BRUNSWICK STEAM ELECTRIC PLANT, UNIT NO. 2

AMENDMENT TO FACILITY OPERATING LICENSE

Amendment No. 19
License No. DPR-62

SUPPORTING AMENDMENT NO. 19 TO LICENSE NO. DPR-62

| FIG. NO. | 67-3 | PLANT STAFF ORGANIZATION | CAROLINA POWER & LIGHT COMPANY BRUNSWICK STEAM ELECTRIC PLANT UNITS 1 & 2 Final Safety Analysis Report |

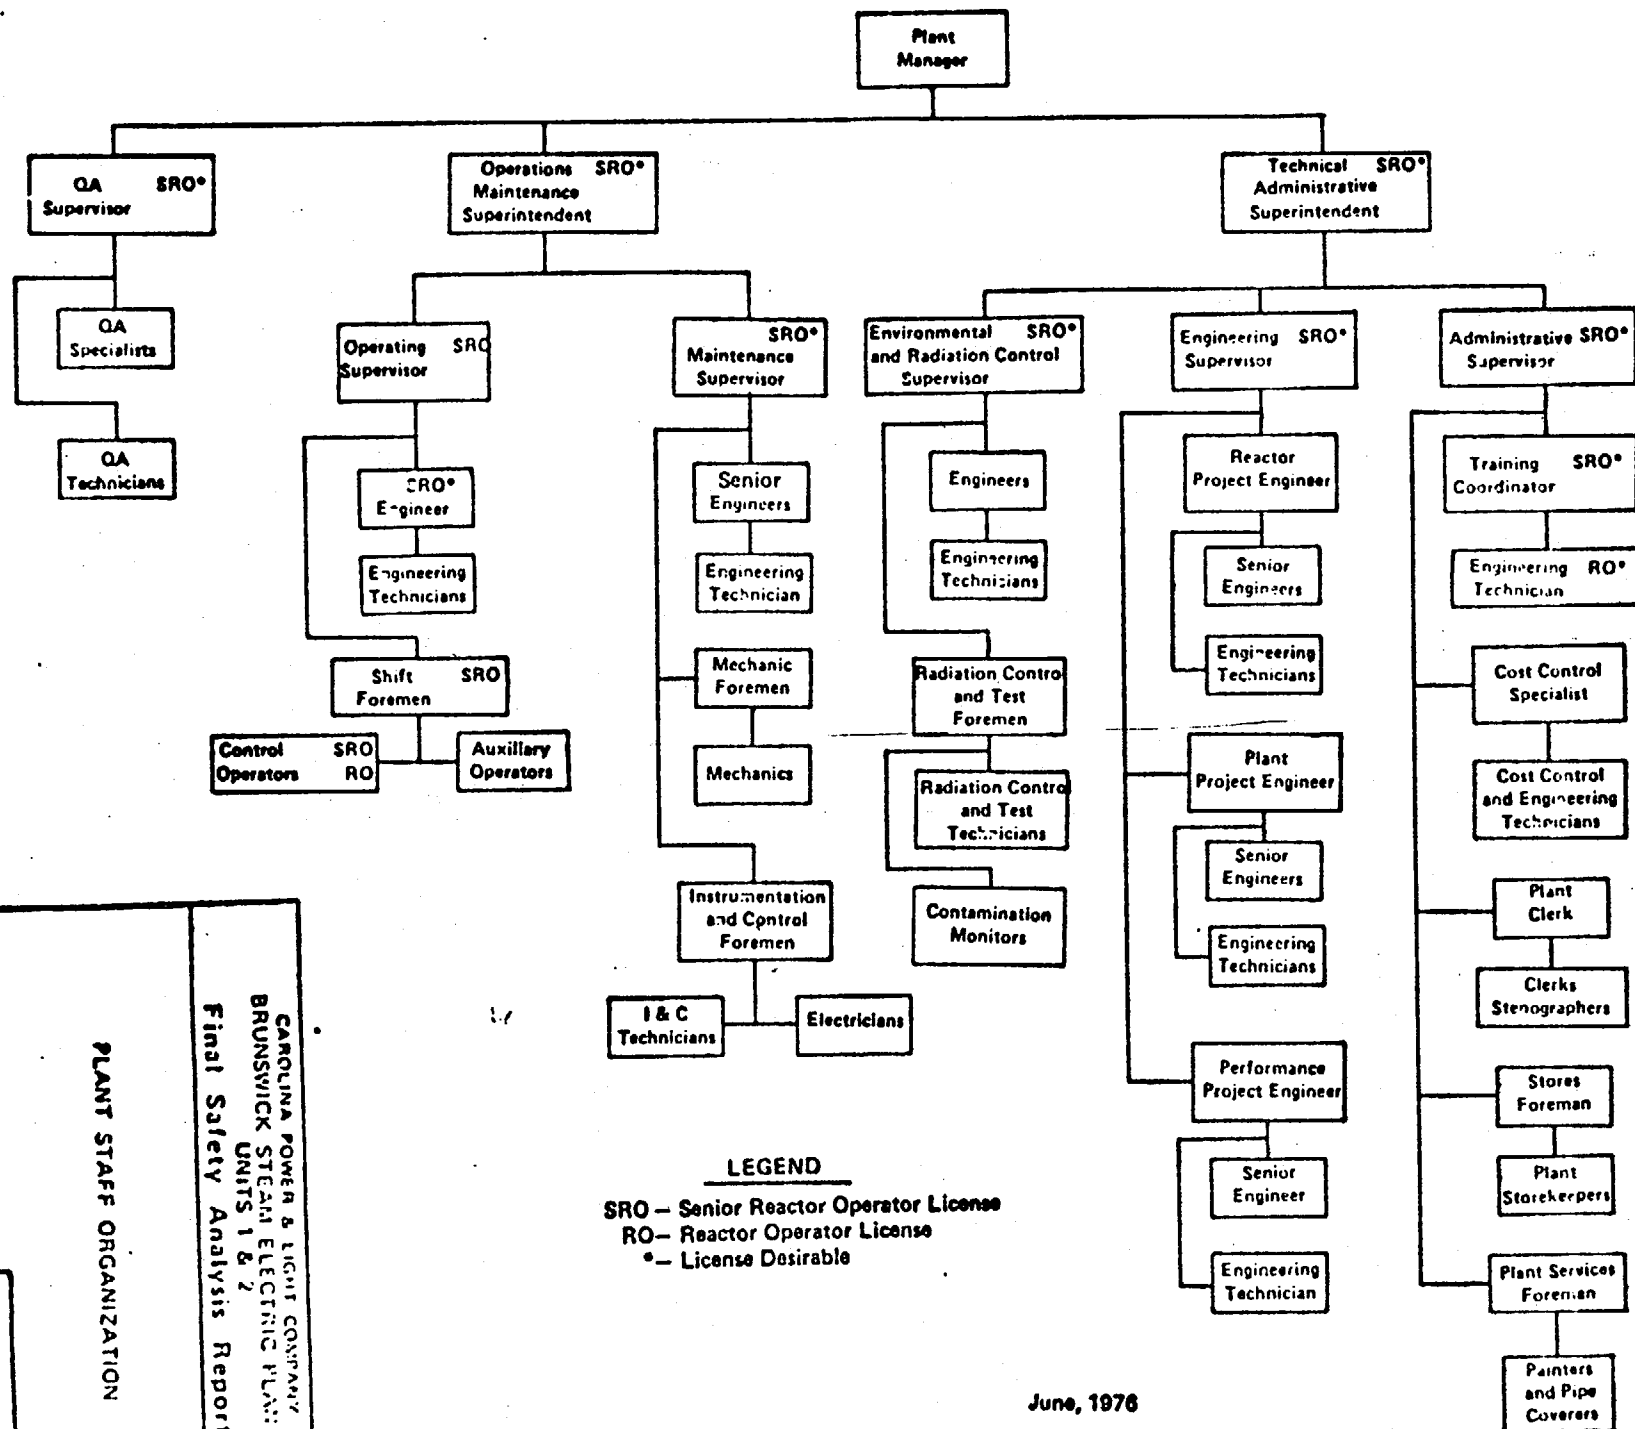
Under the present organizational structure, the Plant Manager has four department heads reporting to him: a QA Supervisor, an Environmental & Radiation Control Supervisor, a Plant Superintendent, and an Administrative Supervisor. The Plant Superintendent is assisted by an Operating Supervisor, an Engineering Supervisor, and a Maintenance Supervisor.

The proposed organization would change the name of the Plant Superintendent to Operations-Maintenance Superintendent, with the Operations Supervisor and the Maintenance Supervisor reporting to him. In addition, a new position, Technical-Administrative Superintendent, would be established with the Administrative Supervisor, Engineering Supervisor, and the Environmental & Radiation Control Supervisor all reporting to him.

The licensee states that the proposed revised plant organization will permit more effective administration of an increased plant staff and will make possible more efficient operations (a second unit is scheduled for operation later this year). We have reviewed the proposed changes and find that the revised organization continues to meet the recommendations of Regulatory Guide 1.33, "Quality Assurance Program Requirements," which endorses proposed standard ANS 3.2 and has been subsequently issued as ANSI N18.7-1972, "Standard for Administrative Controls for Nuclear Power Plants." The qualifications with regard to educational background and experience of key supervisory and professional personnel will continue to meet or exceed the recommendations of ANSI N18.1-1971, "Selection and Training of Nuclear Power Plant Personnel." We, therefore, find the proposed organizational change acceptable.

| FIG. NO. | 6.5-1 |

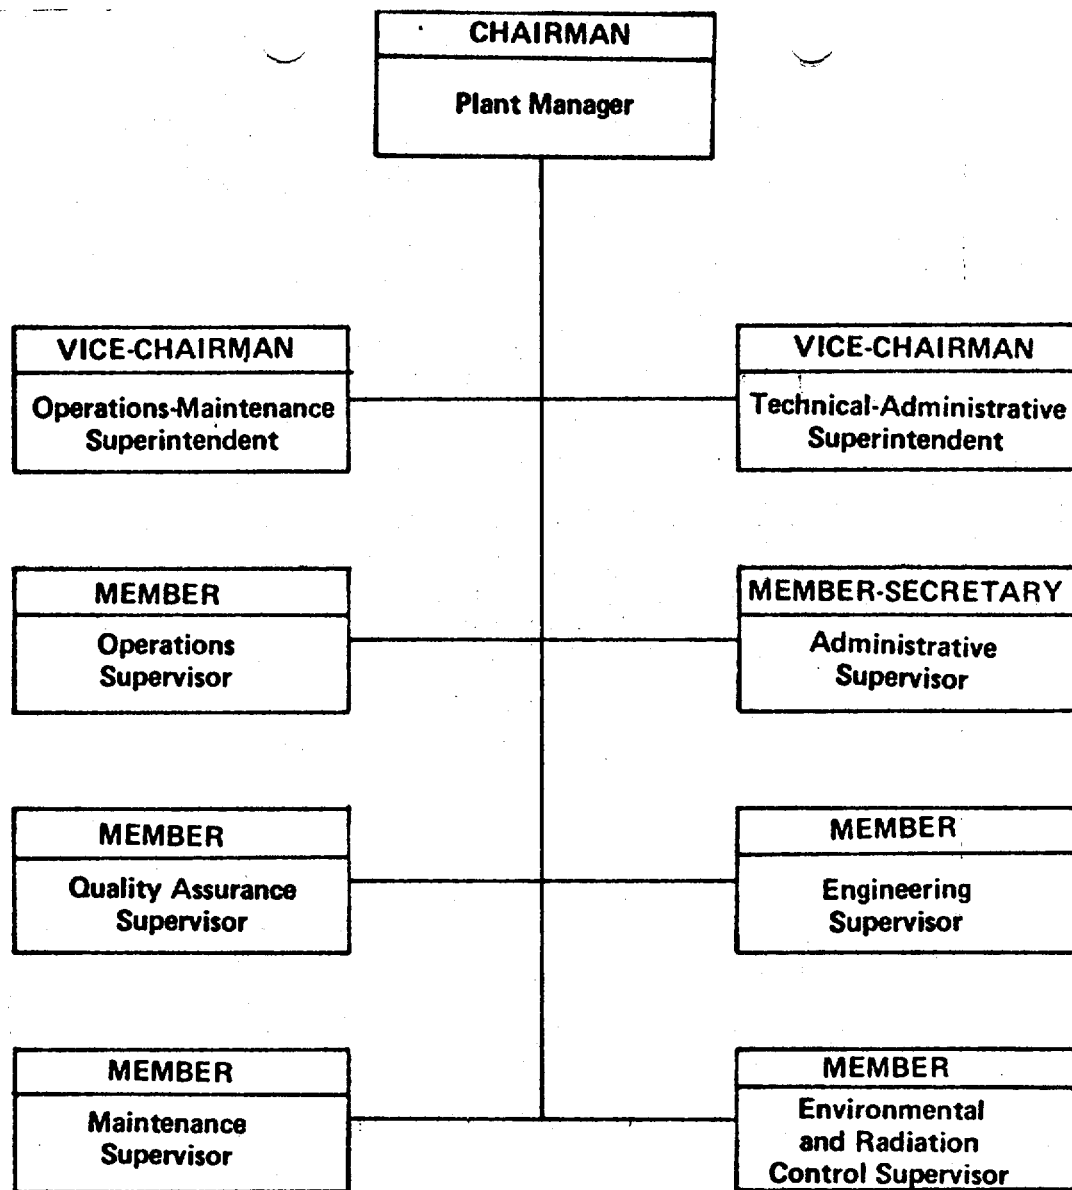
The proposed revision to the on-site Plant Nuclear Safety Committee would reflect these organizational changes by adding the Technical-Administrative Superintendent as a Vice Chairman, changing the title of the other Vice Chairman from Plant Superintendent to the new title of Operations-Maintenance Superintendent, and changing the status of the Operations Supervisor from Vice Chairman to member.

The proposed changes to the Plant Nuclear Safety Committee reflect the organizational changes discussed above, do not alter the functions or operations of the Committee, and are acceptable.

| FIG. NO. | 5.1-1 |

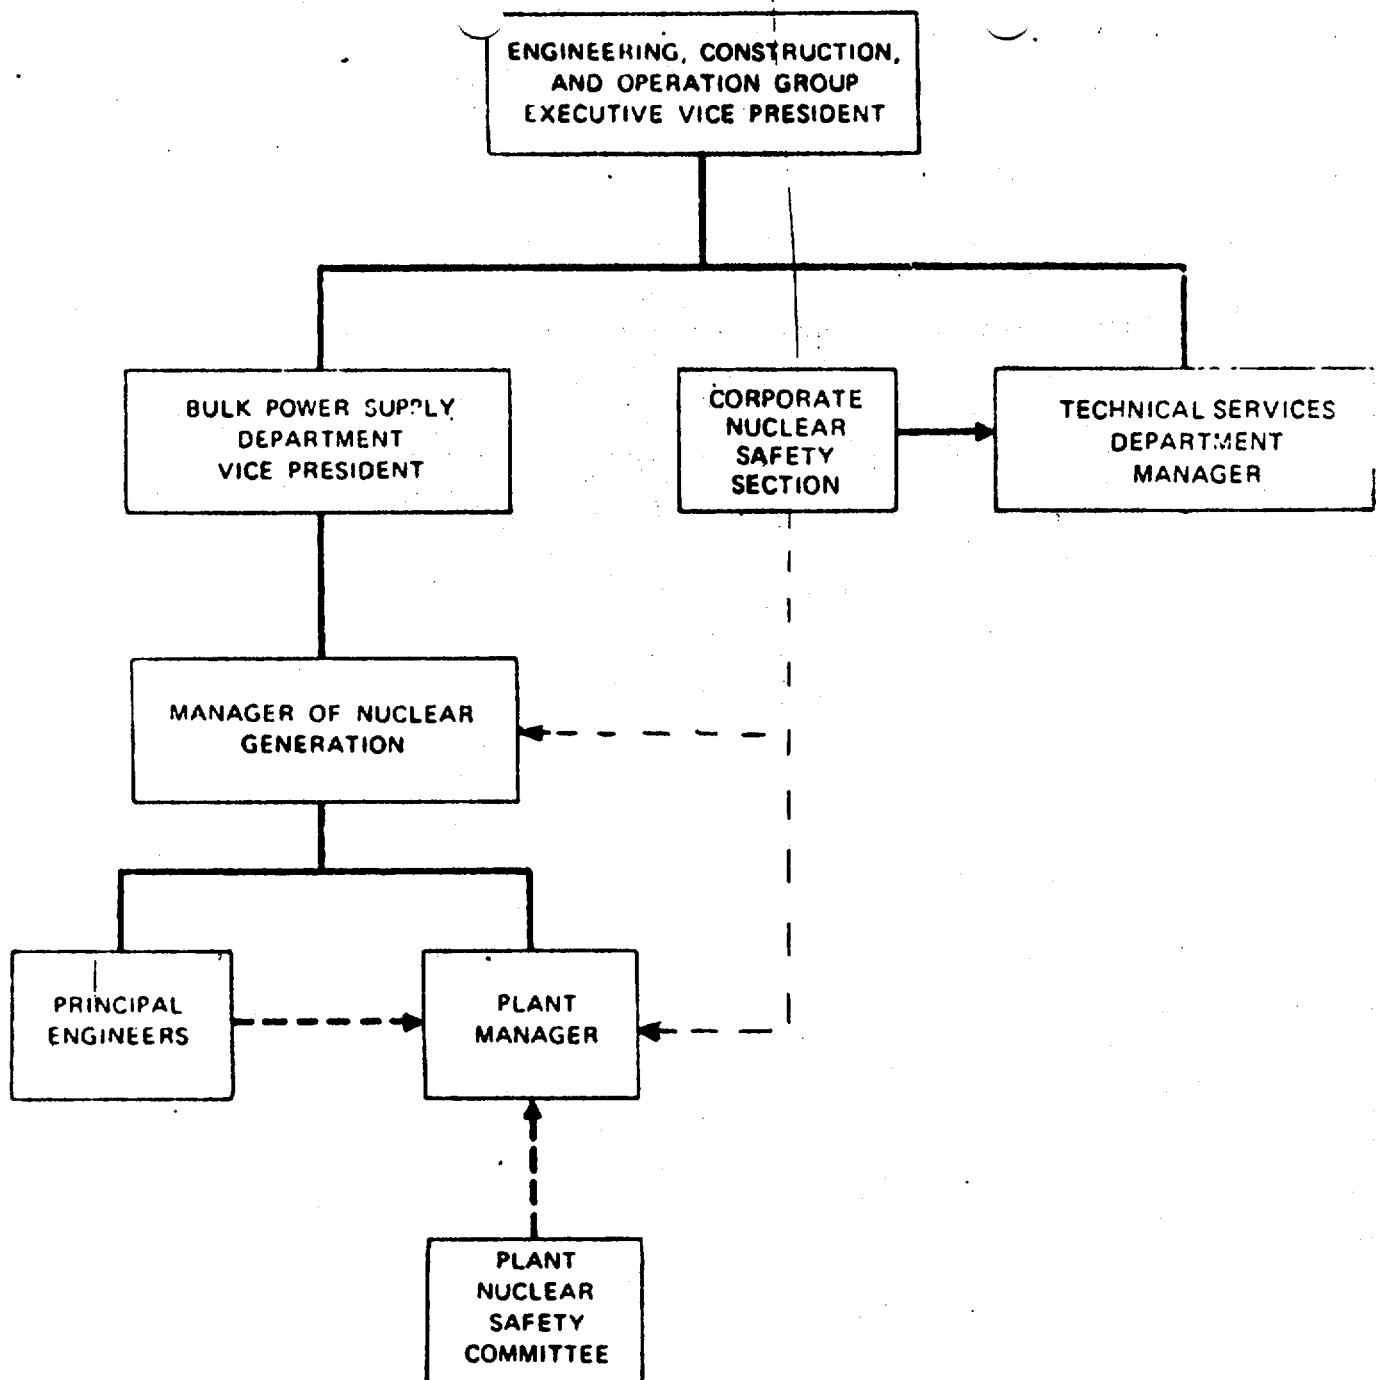
The proposed change to the Special Services Department would rename this department the Technical Services Department.

The proposed change to the title of the Special Services Department to the Technical Services Department is a renaming only and does not affect the function of the Manager, Corporate Quality Assurance Audit Section, or the Manager, Corporate Nuclear Safety Section, who would both now report to the Manager, Technical Services Department. We, therefore, find the proposed change acceptable.
